Ref: PEG-1155-93M-CN-HI-BOA-LET-ES-10436
Jean Marc Decloquement
Consortium Director
Blocks 277-278,2nd business sector,
Teseen st, Shaker Consultancy Building
New Cairo, Egypt.

Project: Engineering, Procurement and Construction of the New Administrative Capital Monorail and 6th October City Monorail (Contract 93/Metro).

Subject: Comments on shop drawings. // 93M-BOA-NAT-LOT-26138

6TH OF OCTOBER MONORAIL
SHOP DRAWING FOR LINE SEGMENT (L00)
WALK WAY : C-1

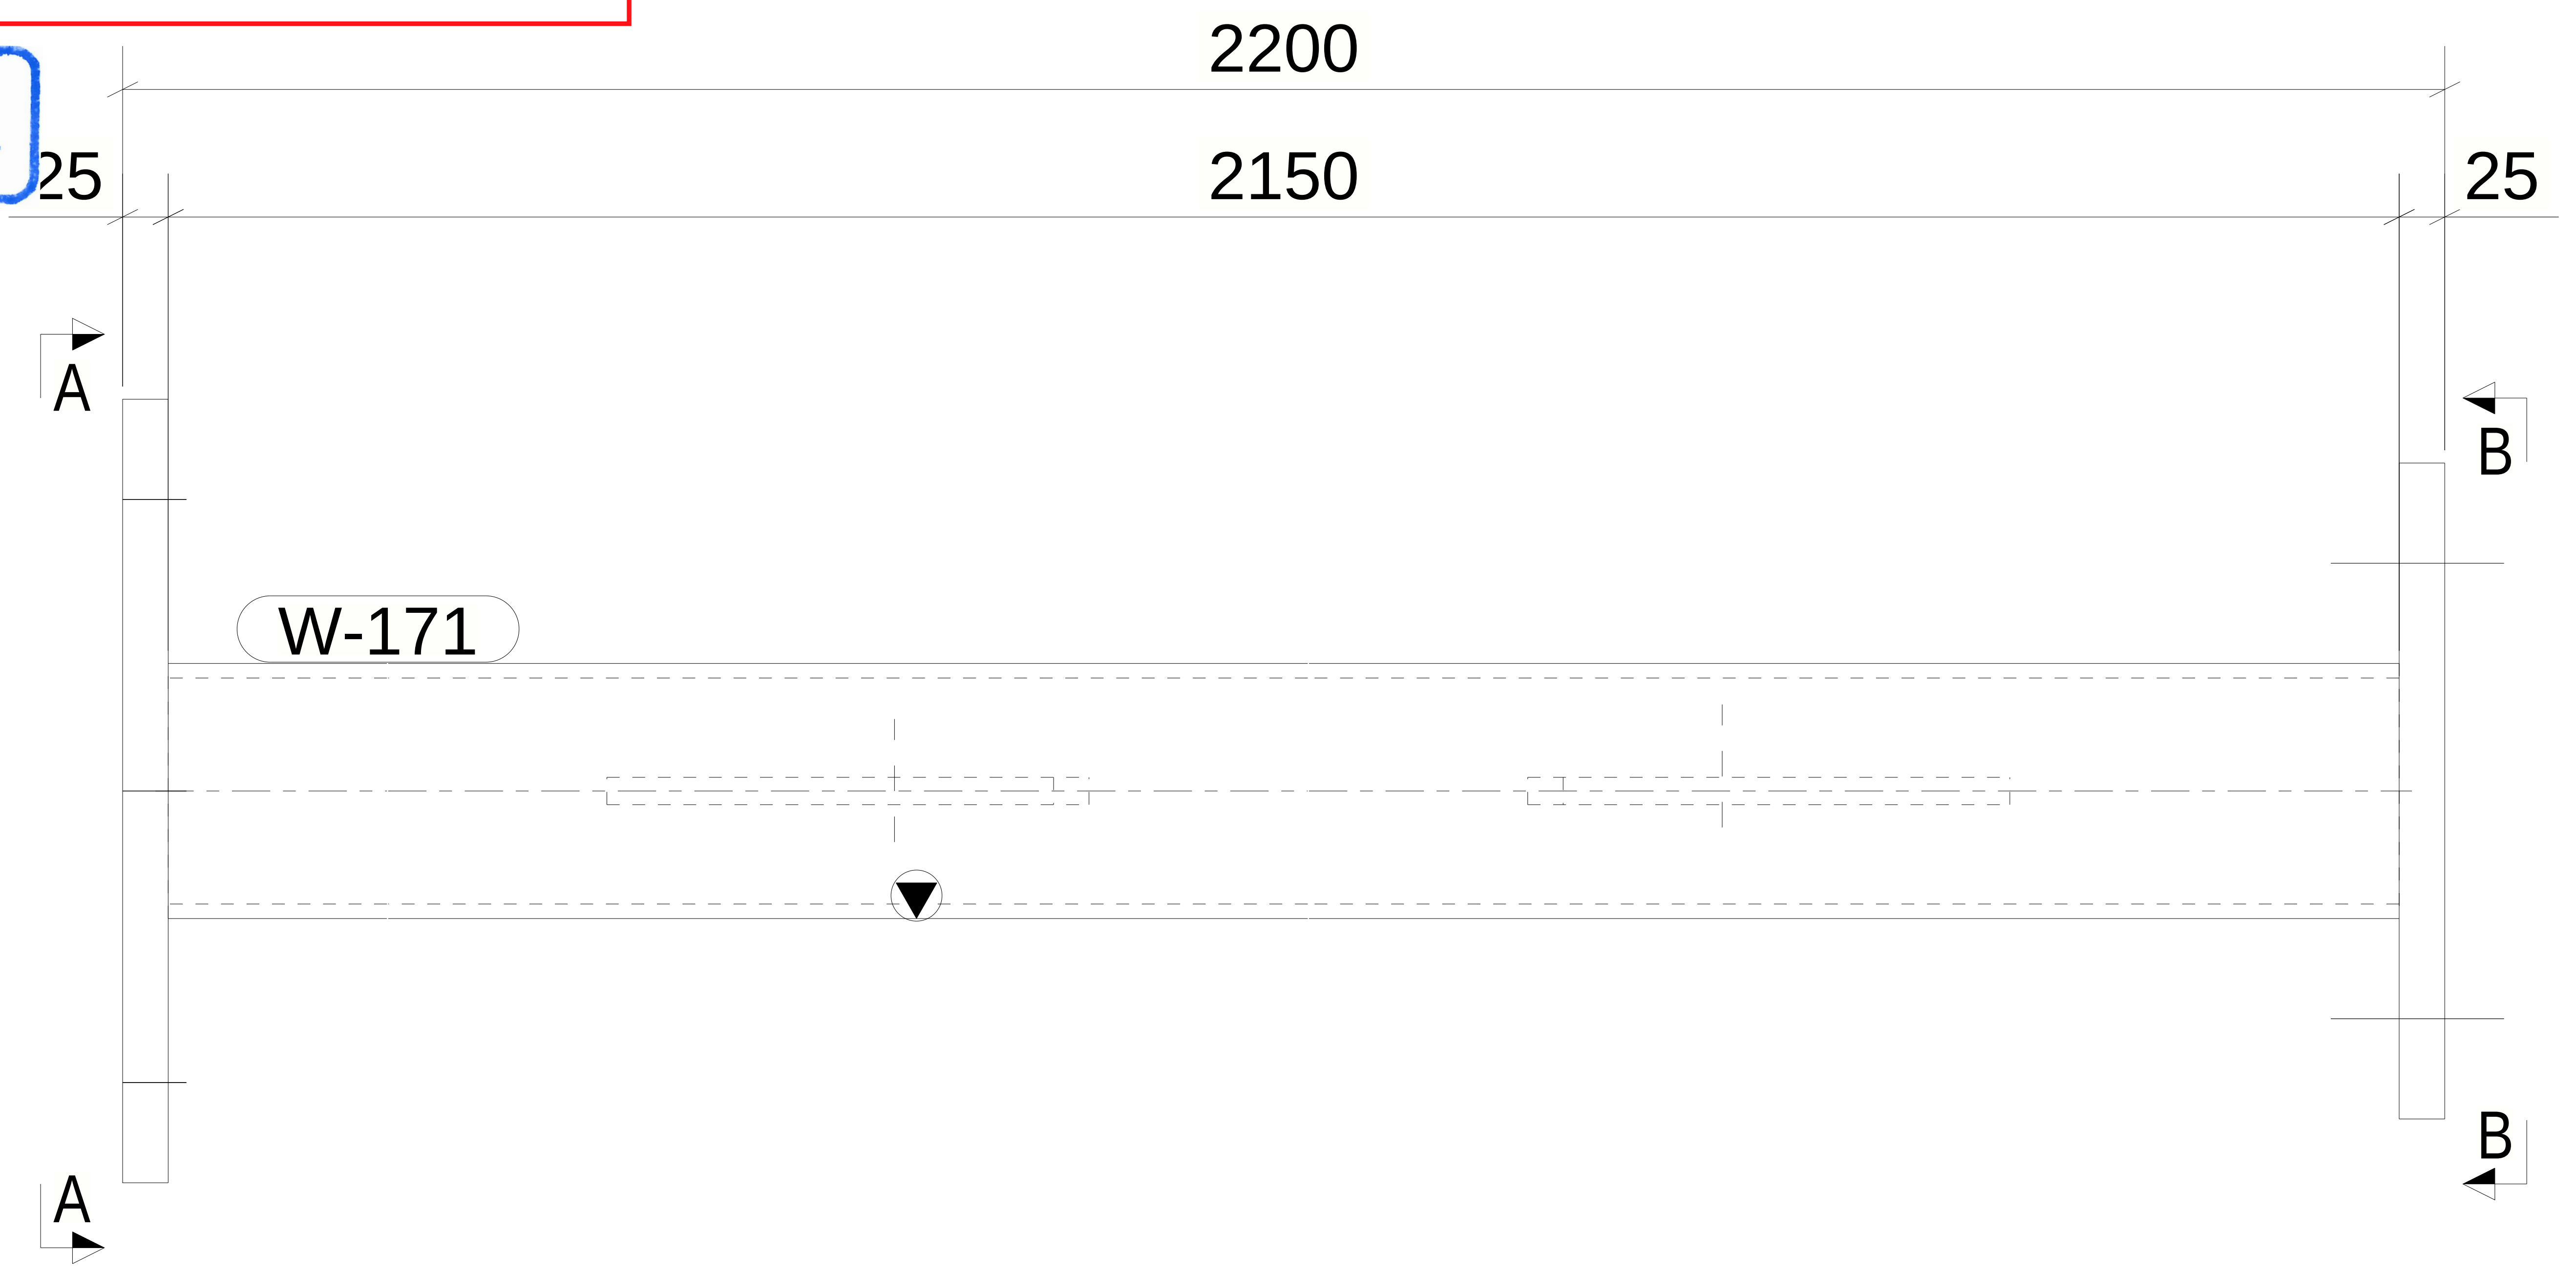
Please refer to the design reference snap below for the size of slot and show it on the drawing.

6TH OF OCTOBER MONORAIL
SHOP DRAWING FOR LINE SEGMENT (L00)
WALK WAY : CHQ-1

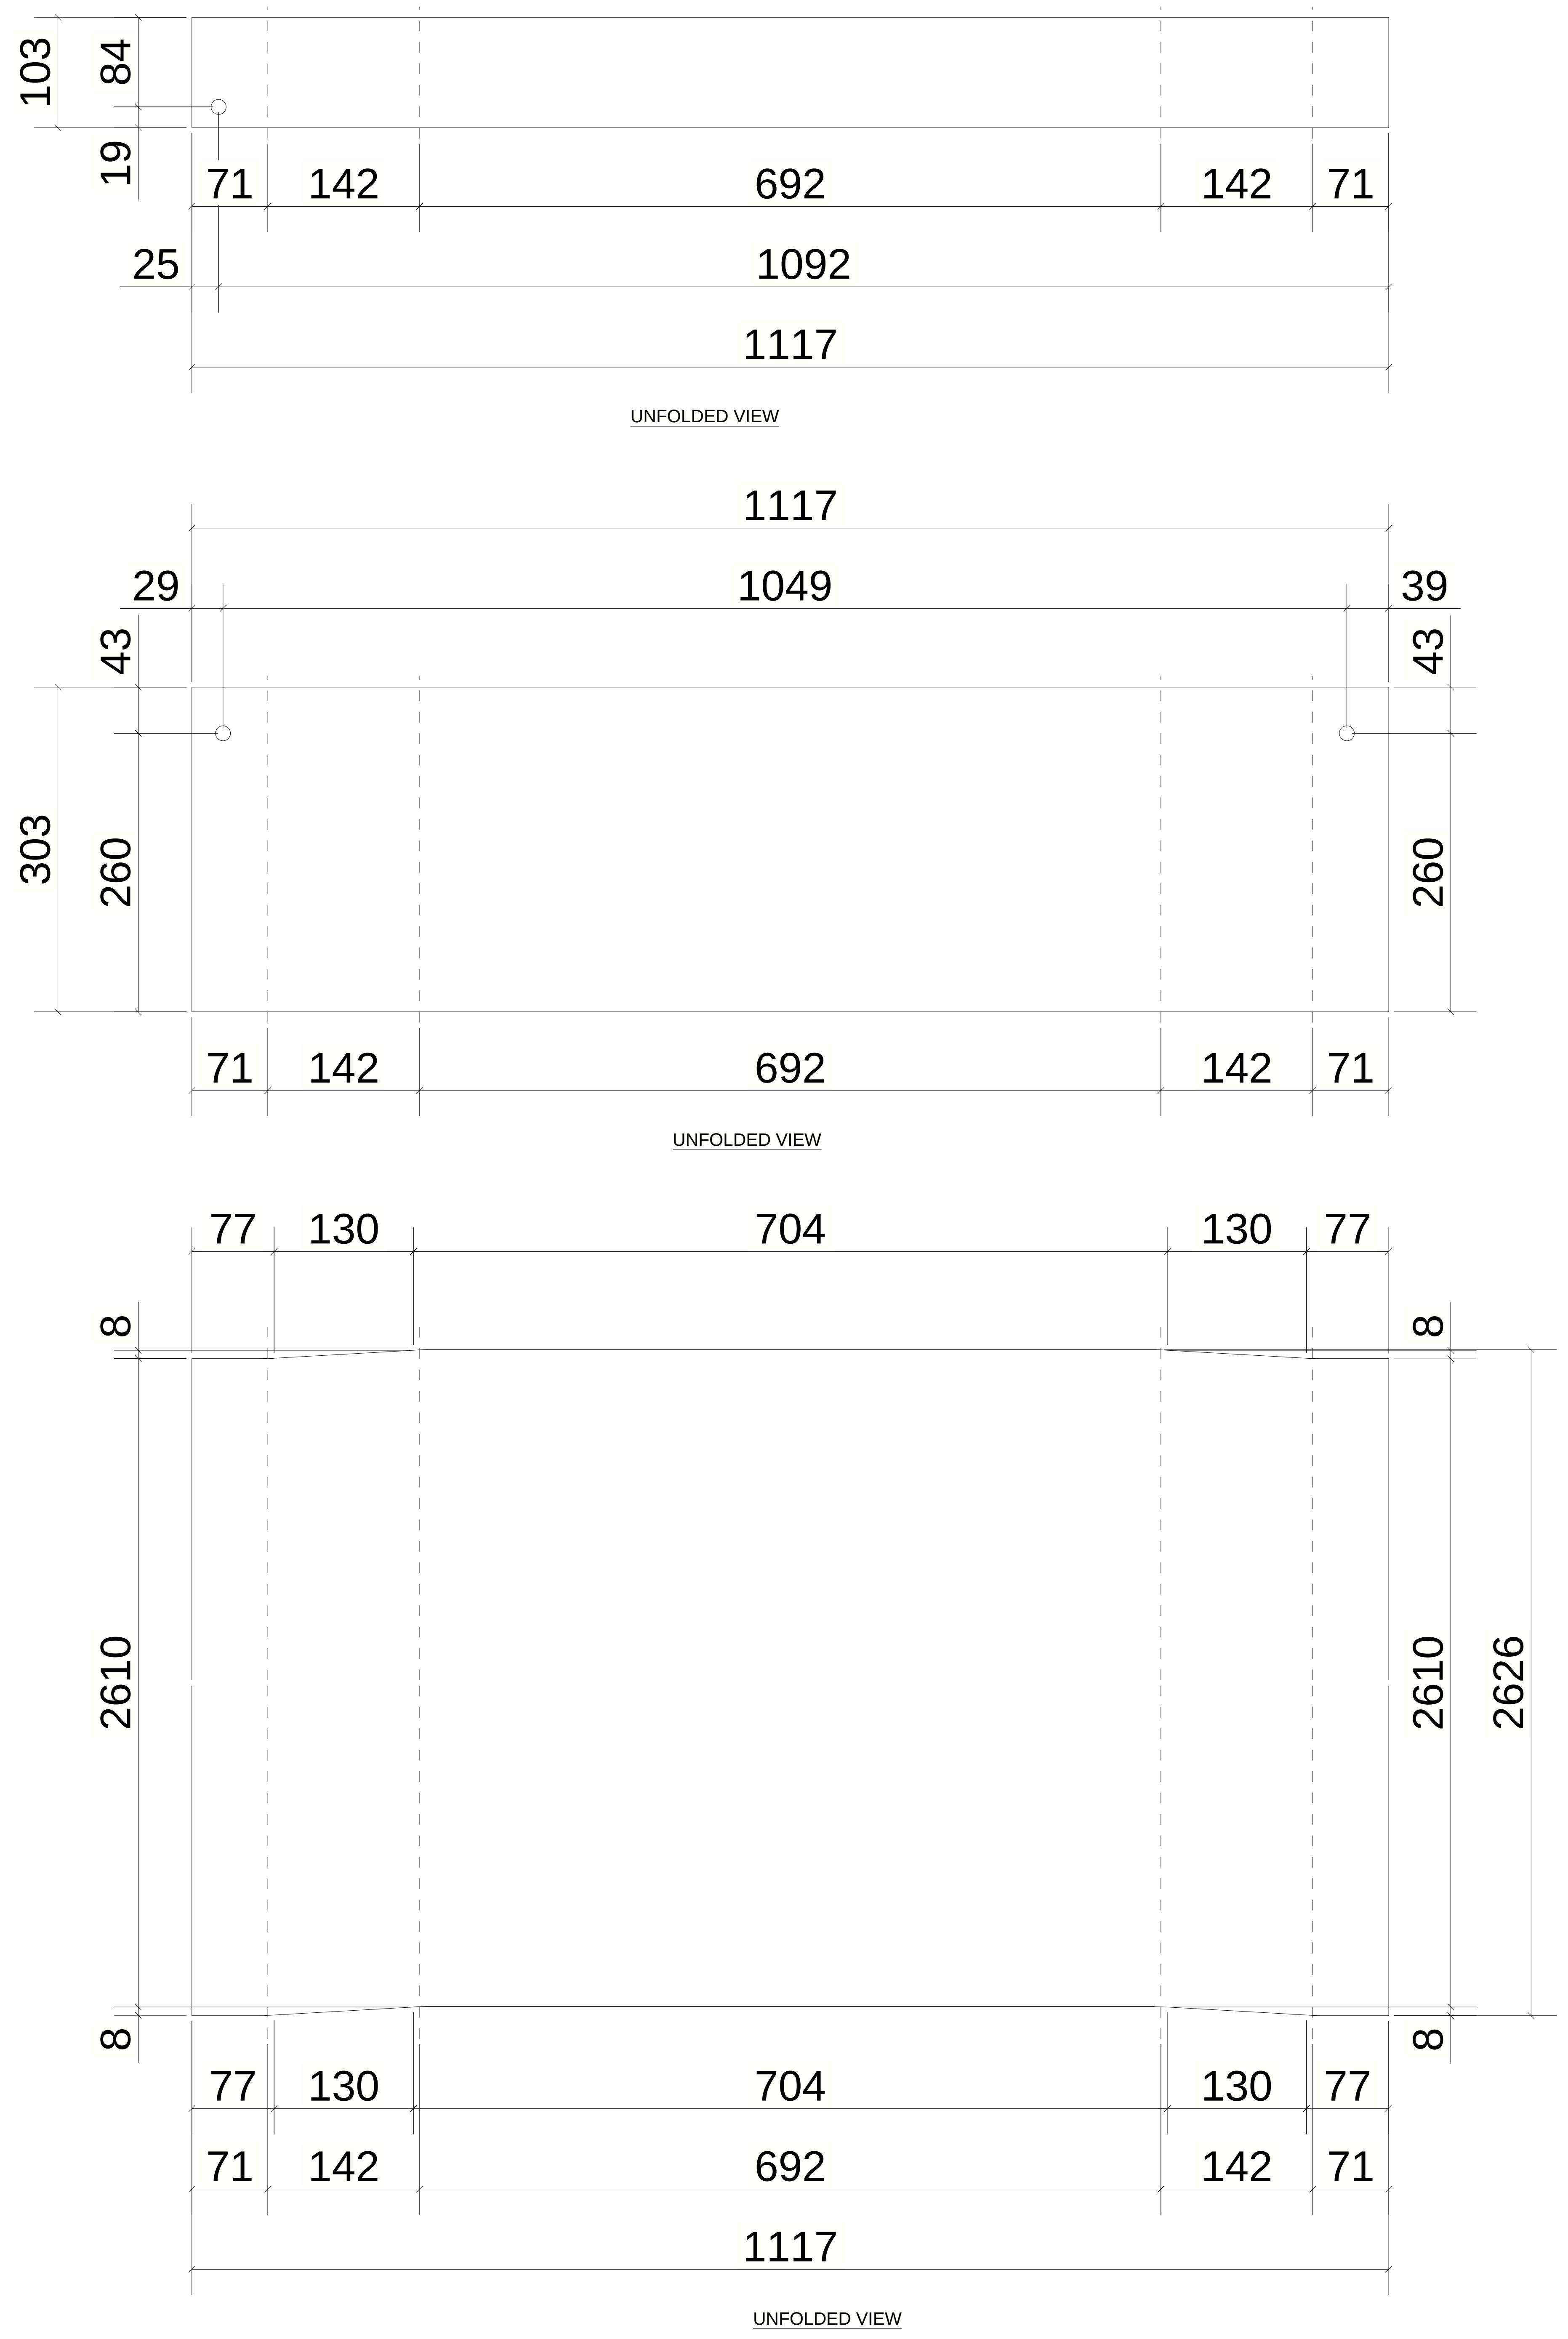
-For all planks assemblies slots and holes size are missing

6TH OF OCTOBER MONORAIL
SHOP DRAWING FOR LINE SEGMENT (L00)
WALK WAY : CHQ-9

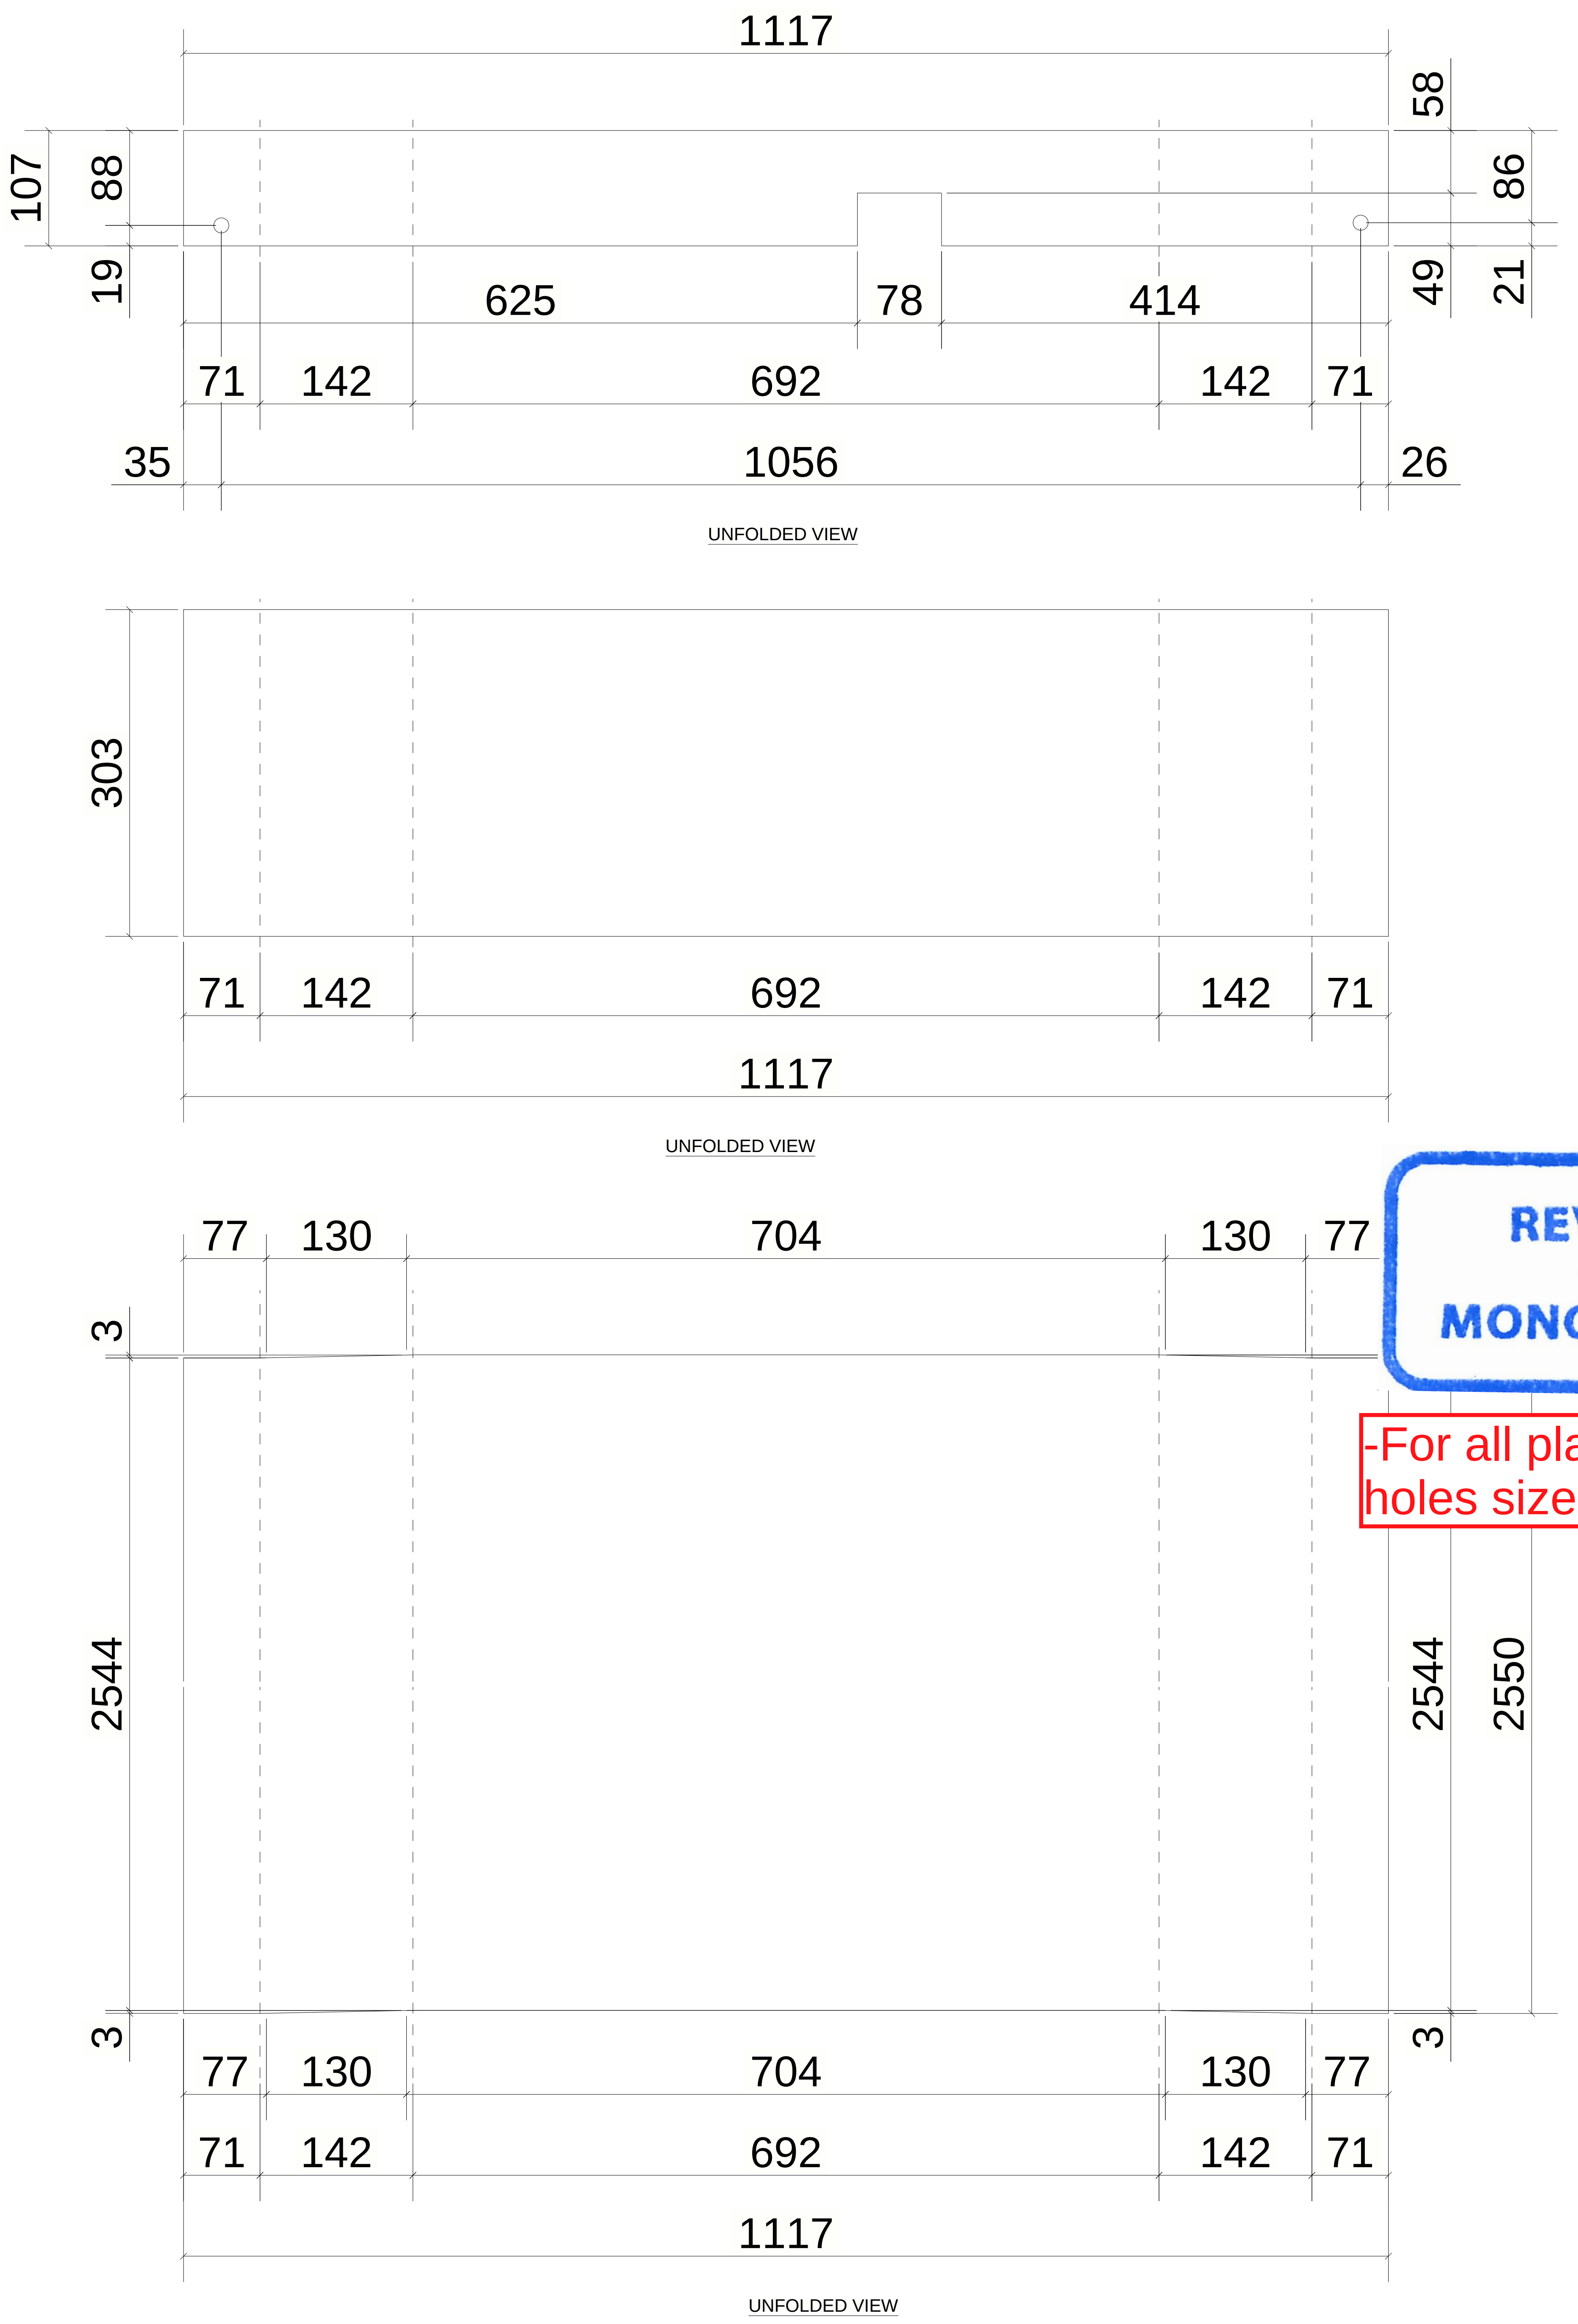
-For all planks assemblies slots and holes size are missing
